**CONCEPTUAL SERVICING AND
STORMWATER MANAGEMENT REPORT**

3200 REID'S LANE SUBDIVISION

**Re: Conceptual Servicing and Stormwater Management Report
Reid's Lane Subdivision
Response to Comments
Our File No.: 119089**

Re: Draft Plan of Subdivision Application – 3200 Reid’s Lane (3rd review)

DRAWING No.
119089-SWMF

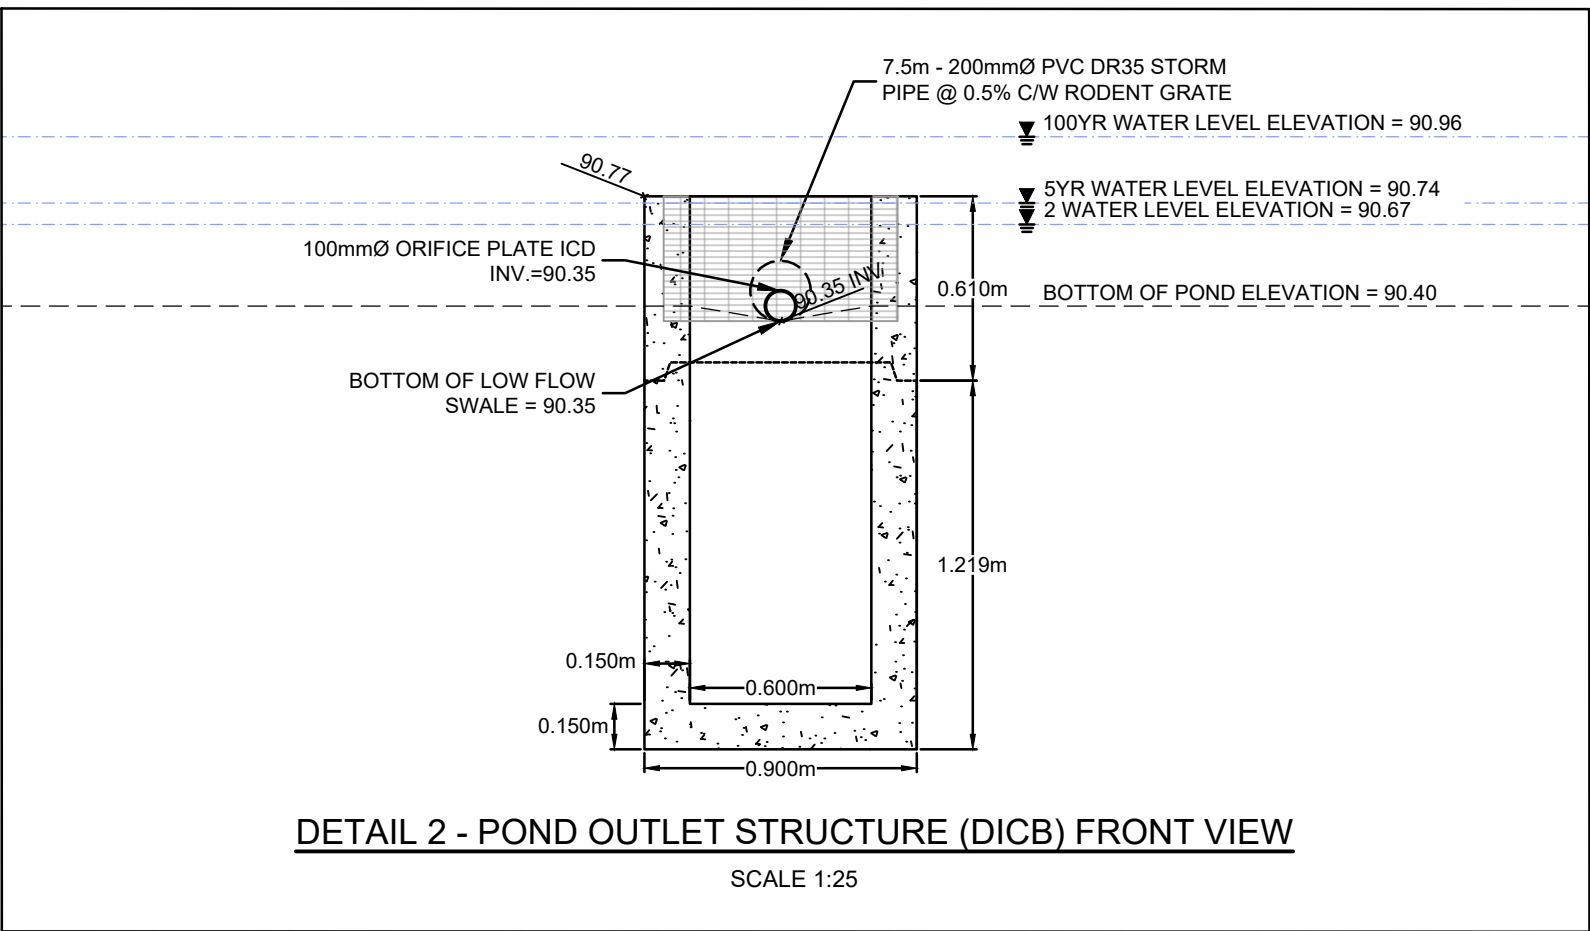
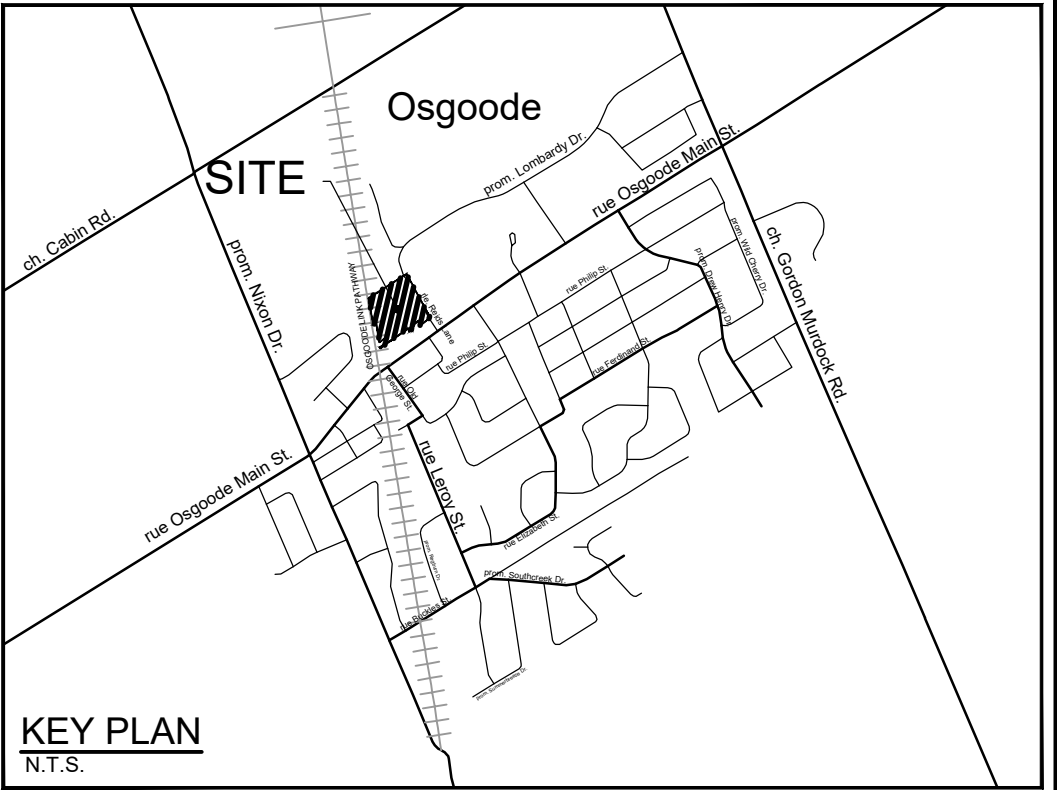
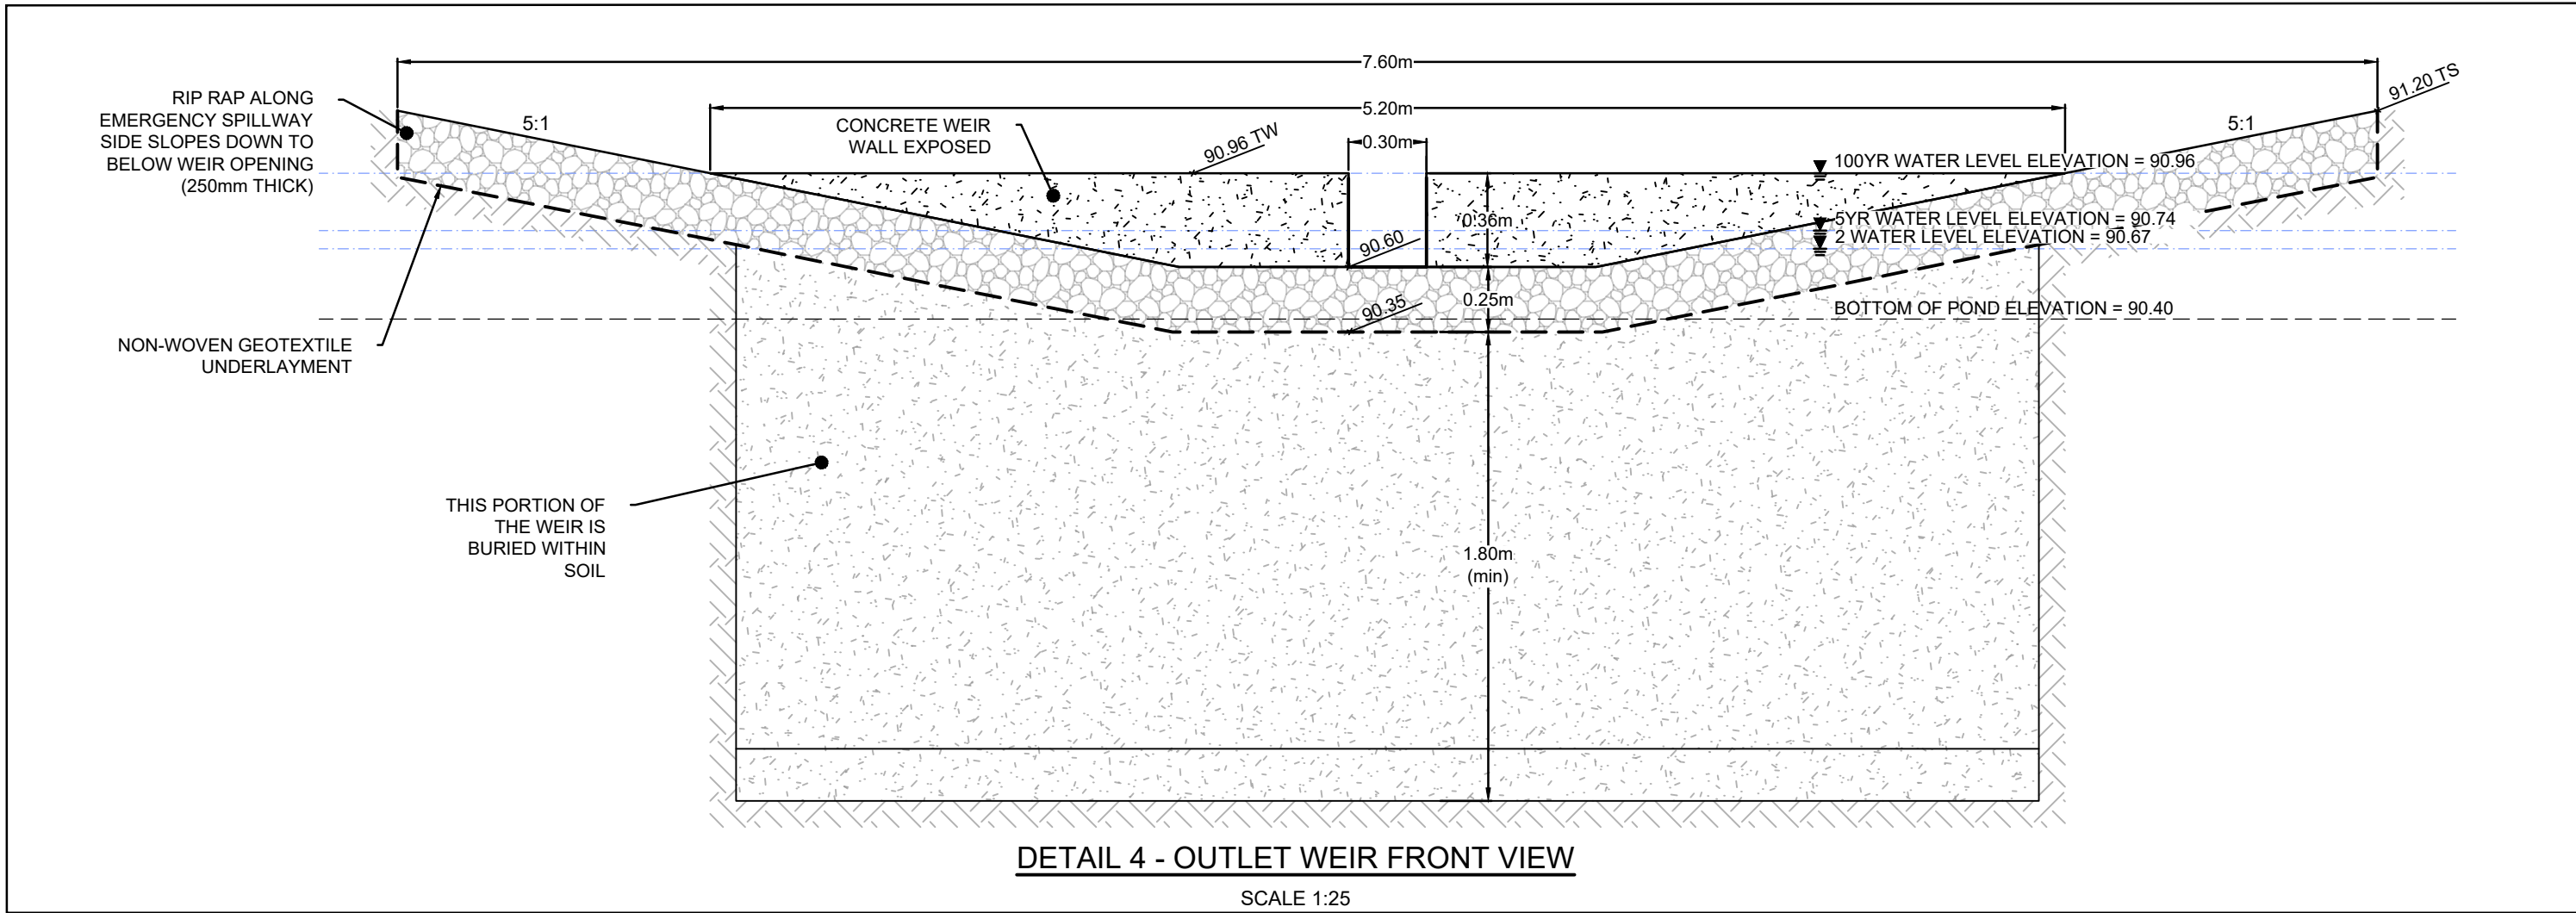
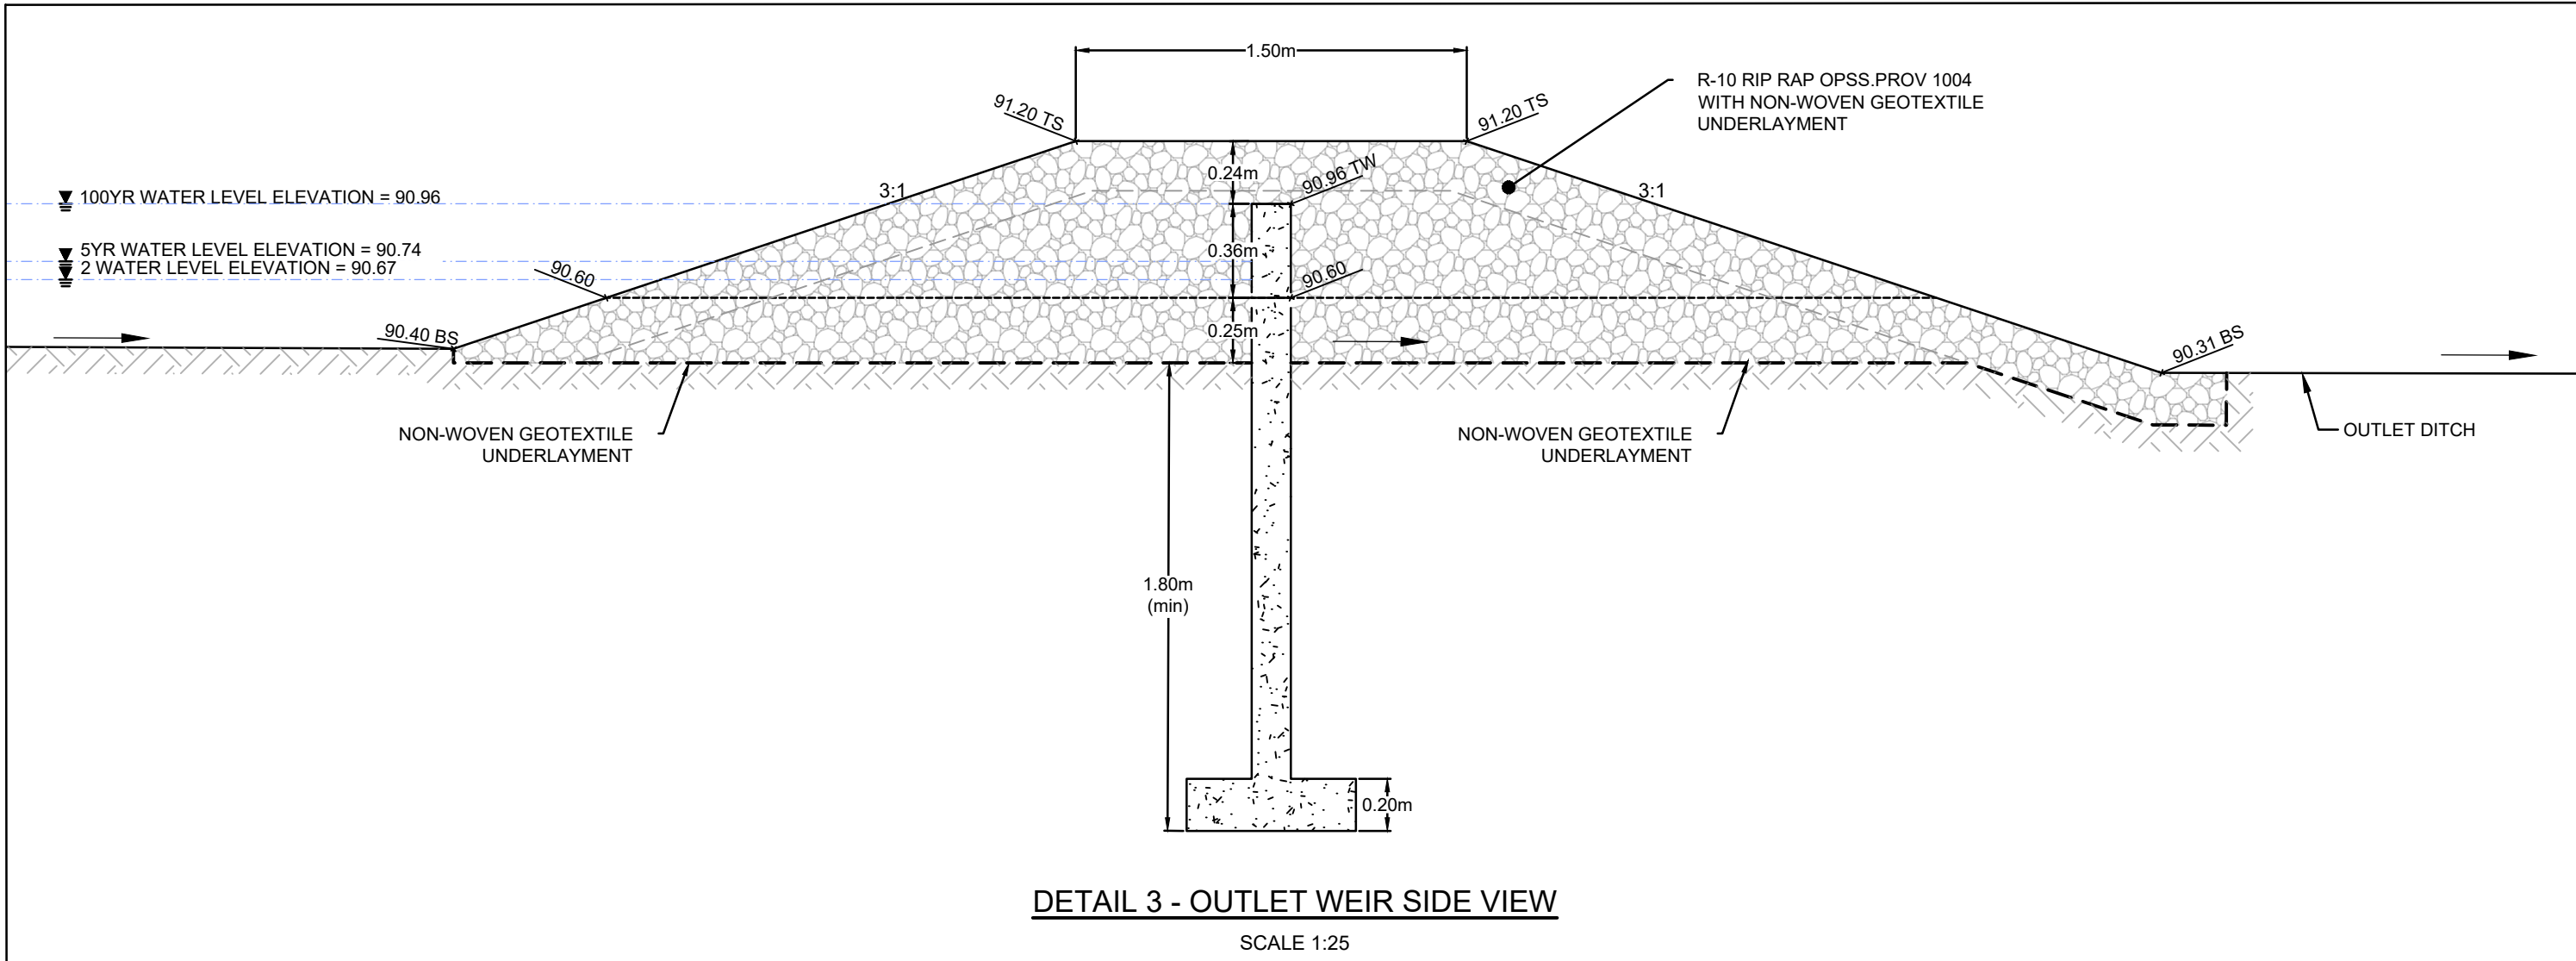
10. The detail of the inlet to the pond is required.
11. The location of the pond against the property line would not allow an industrial lawn mower to cut grass between the property line and the slope of the pond.
12. The outlet weir with the 0.09m wide is susceptible to plugging by debris.
13. Please assure that the pond will function as a dry SW facility and have positive outlet and will not be soggy. In addition, please provide us with calculations that the pond will not back up to the adjacent lots at the Lombardy Way cul-de-sac.
14. Further comments provided by the City's Stormwater Management Modelling Review Unit are enclosed.

The location of the dry pond is shown on the Preliminary Grading & Site Servicing Plan (**119089-PGR**). The details on the design of the dry pond and flow control structure are provided on the Stormwater Management Pond Facility plans (**119089-SWMF** and **119089-SWMF1**).
